PROJECT : HONOAPIILANI HIGHWAY
Kahana to Alaeloa

PROJECT NO.: F-030-1(13)

DRAINAGE

STATE OF HAWAII
DEPARTMENT OF TRANSPORTATION
LAND TRANSPORTATION FACILITIES DIVISION
DRAINAGE & IRRIGATION PLAN
HONOAPIILANI HIGHWAY
Kahana to Aiealoa
F.A. Proj. No. F-030-1(13)

STATE OF HAWAII DEPARTMENT OF TRANSPORTATION HIGHWAYS DIVISION	
DRAINAGE & IRRIGATION PLAN	
HONOAPIILANI HIGHWAY Kahala to Alaeos F.A. Proj. No. F-030-1(13)	
Scale: As Shown	Date: Sept., 1977
SHEET No. 60 OF 31 SHEETS

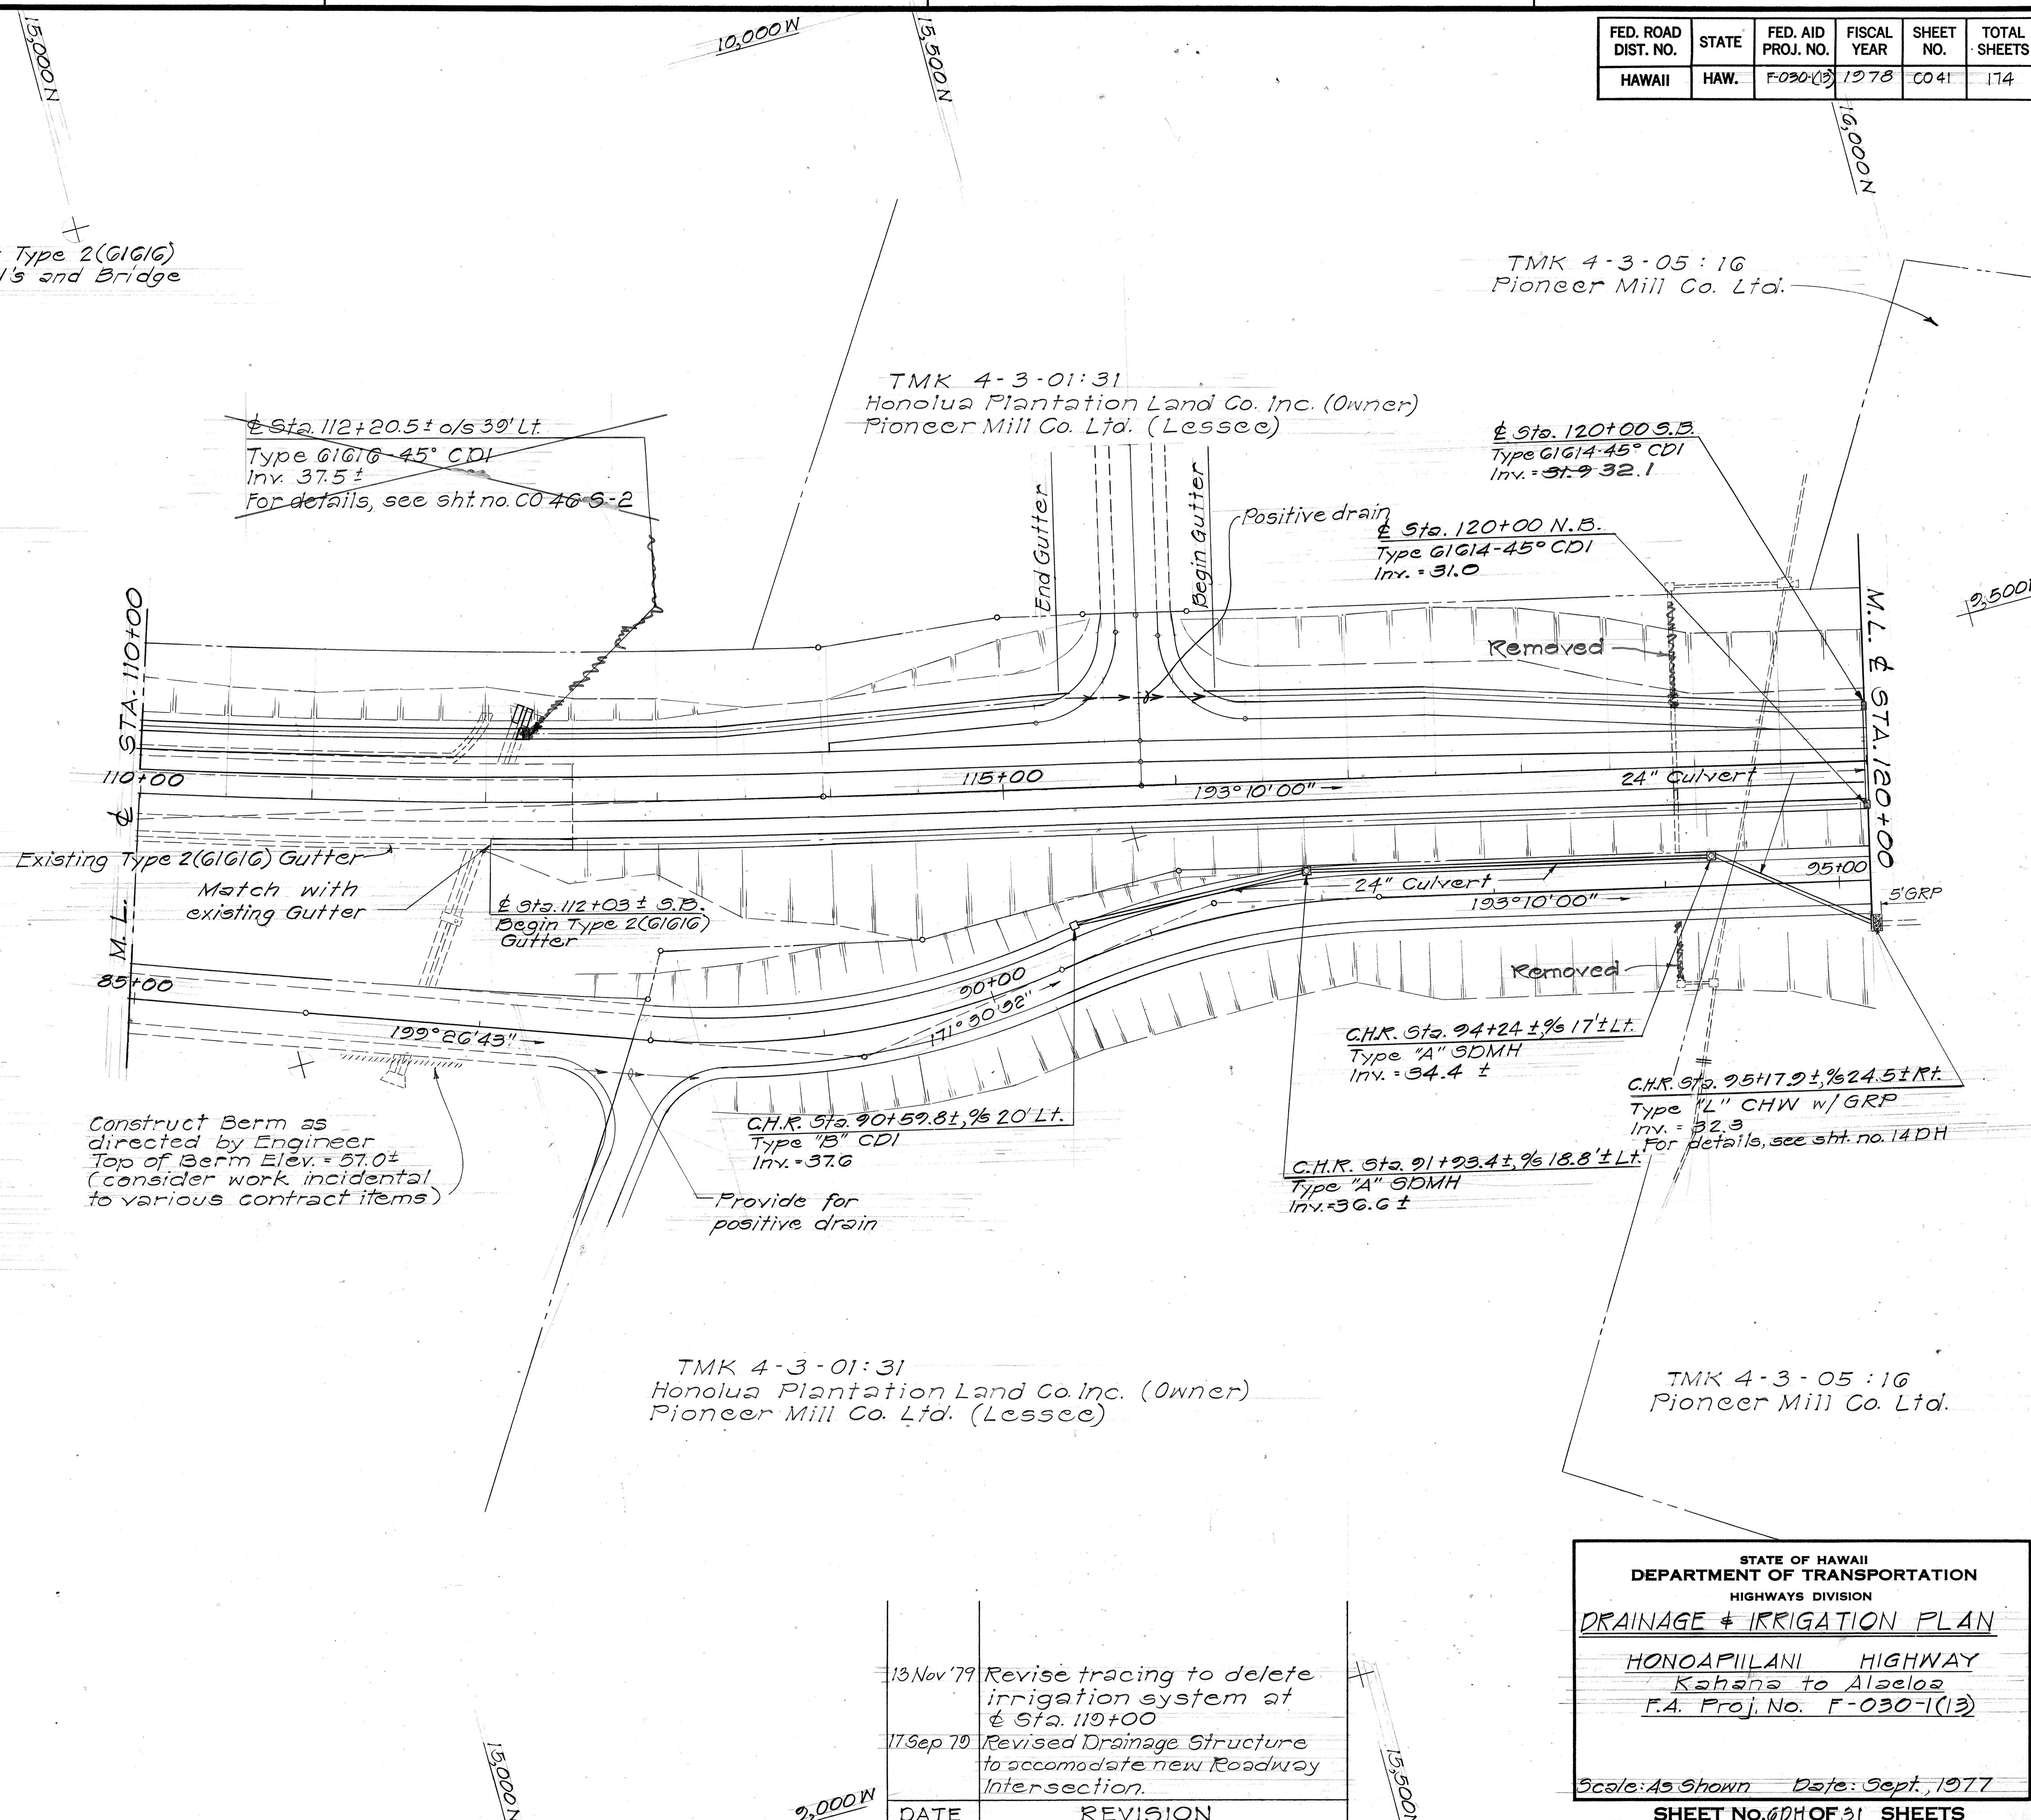
DATE	REVISION
13 Nov '79	Revised tracing to delete irrigation system at Sta. 110+00
17 Sep 79	Revised Drainage Structure to accommodate new Roadway Intersection.

Scale: As Shown Date: Sept., 1977
SHEET NO. 43 OF 31 SHEETS

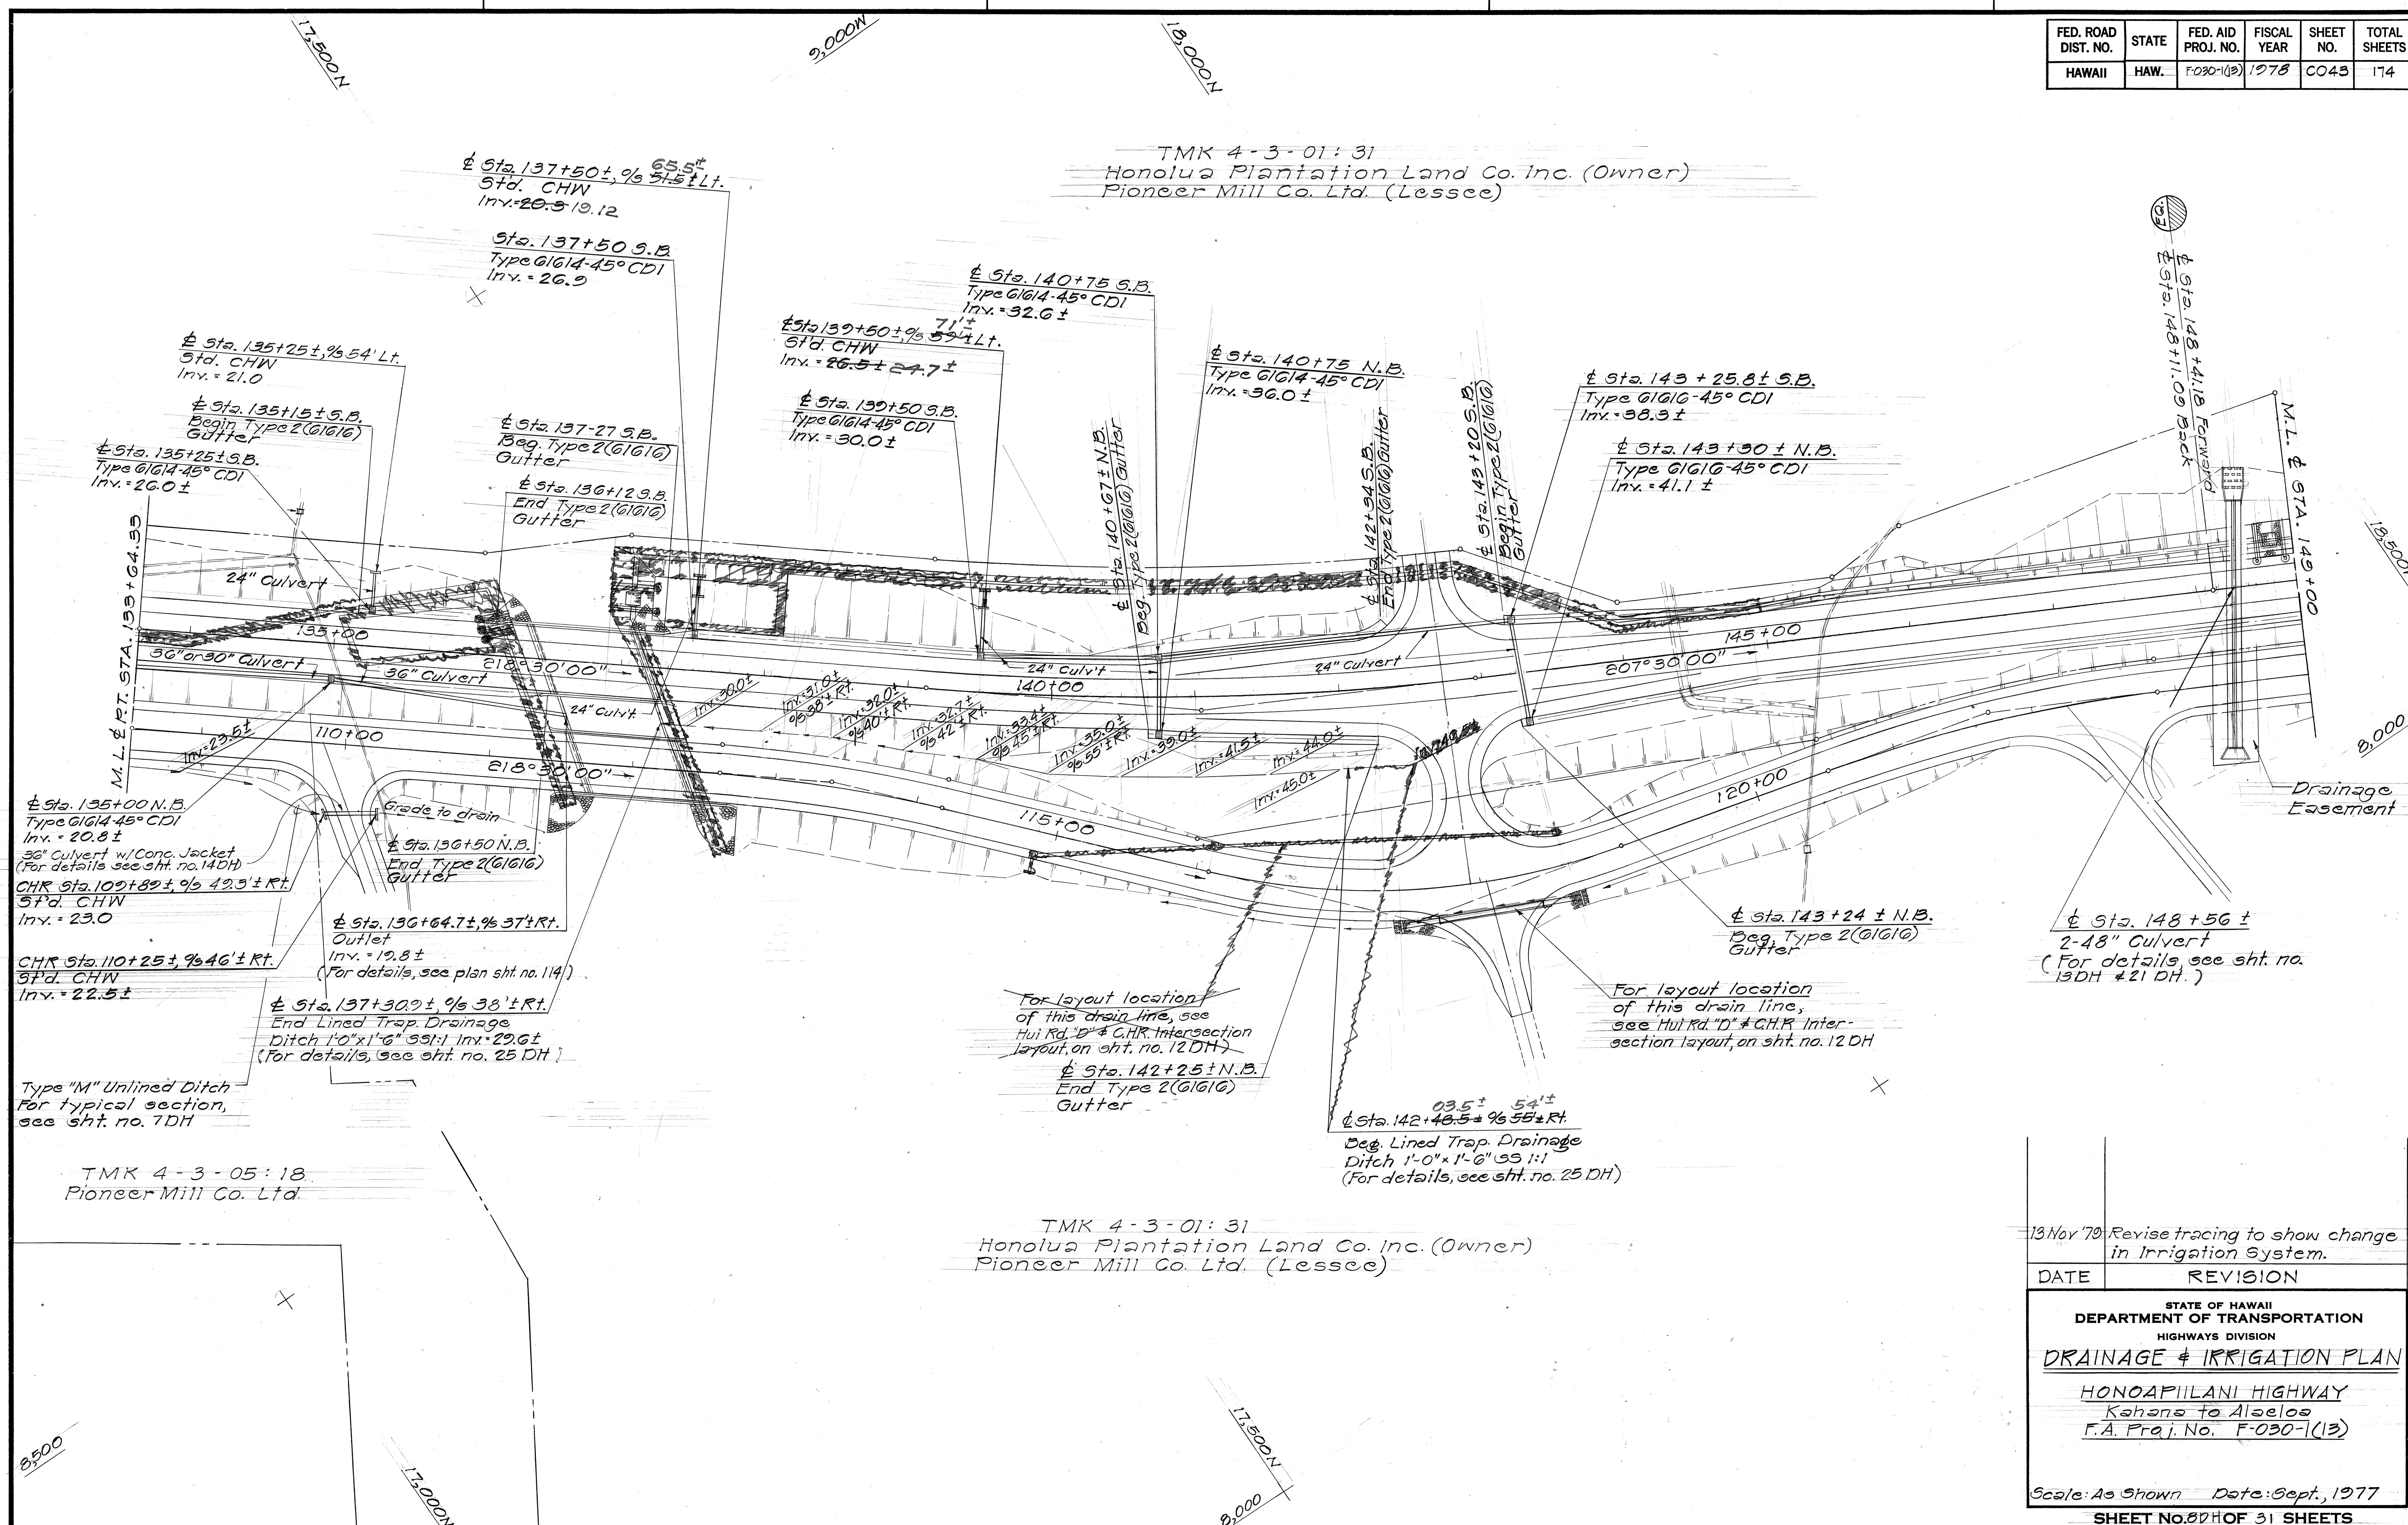
13 Nov '79 Revise tracing to show change in Irrigation System.
